UNITED STATES PATENT AND TRADEMARK OFFICE

APPLICATION NO.	FILING DATE	FIRST NAMED INVENTOR	ATTORNEY DOCKET NO.	CONFIRMATION NO.
10/666,319	09/19/2003	Robert Edward Wilson	10030442-1	7914

Office Action Summary

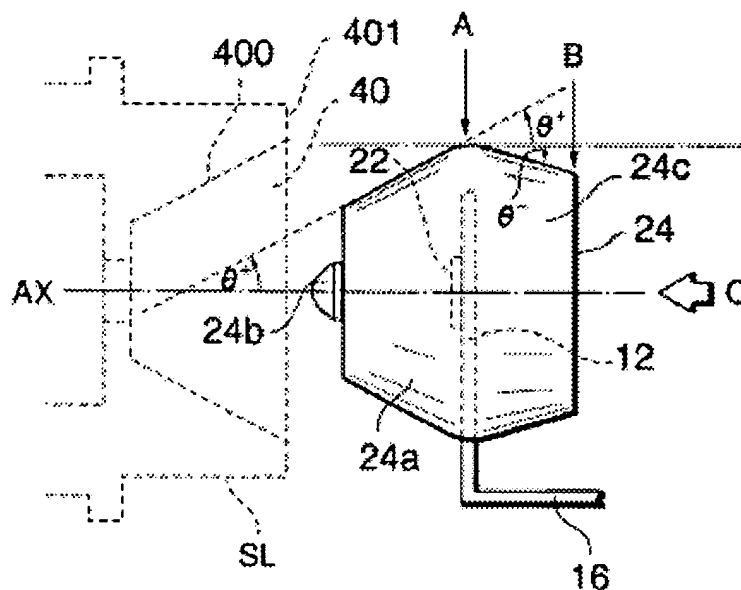
Regarding claim 3, the alignment feature is a cylindrical post, not emphasized in reference but visible in Fig. 7A, the stepped features to the left of the three bore holes (h1, h2, h3). The cylindrical post has a bore hole allowing the emitted light from the package to pass through (Fig. 4A, a long the AX line, Fig. 5C, the central hole). The bore hole allows the light emitting from the condensing lens, in a shape of a solid partial sphere (claim 5), to pass through. Claim 5 is further amended to add the limitation

--the outer surface of the solid partial sphere contacting the inner surface of the single bore of the sleeve--

In Fig. 4A, the particular embodiment shows that the base 24 fits snugly in the element SL thus the solid partial sphere 24b will make contact the inner surface of the sleeve.

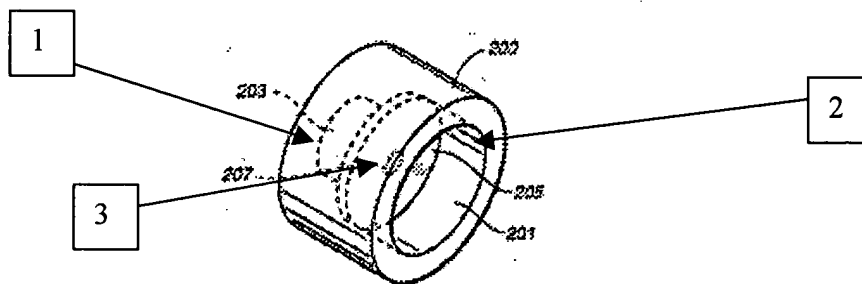
Claim 8 recites:

“The assembly of claim 1, wherein the package is selected from a group consisting of an optoelectronic chip enclosure and a TO can.”

In Irie et al. invention, the head (24) is an optoelectronic chip enclosure. Furthermore, admitted by the Applicant in Fig. 18 (226) that TO can is known as prior art.

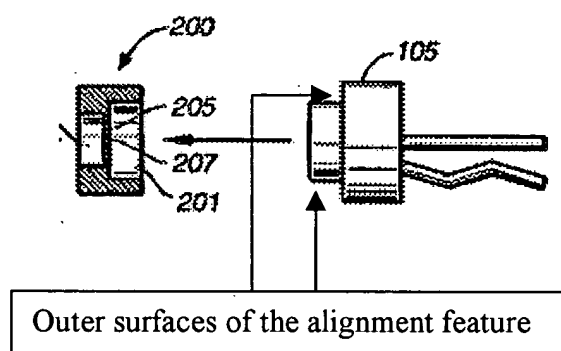
--a constant inner diameter for receiving and contacting outer surfaces of the alignment feature—

The alignment feature is in how the pieces are fitted together along the optical axis and in this case the feature is how element 105 fits into element 200. Once fitted, the outer surface of the sleeve 105 and the surface that is perpendicular to the sleeve are in contact with the constant diameter 2 of element 200. Furthermore, Freeman teaches as prior art that it is well known to incorporate an ST connector into the assembly to couple emitted light from the laser diode to the ferrule (col. 1, line 14-17).
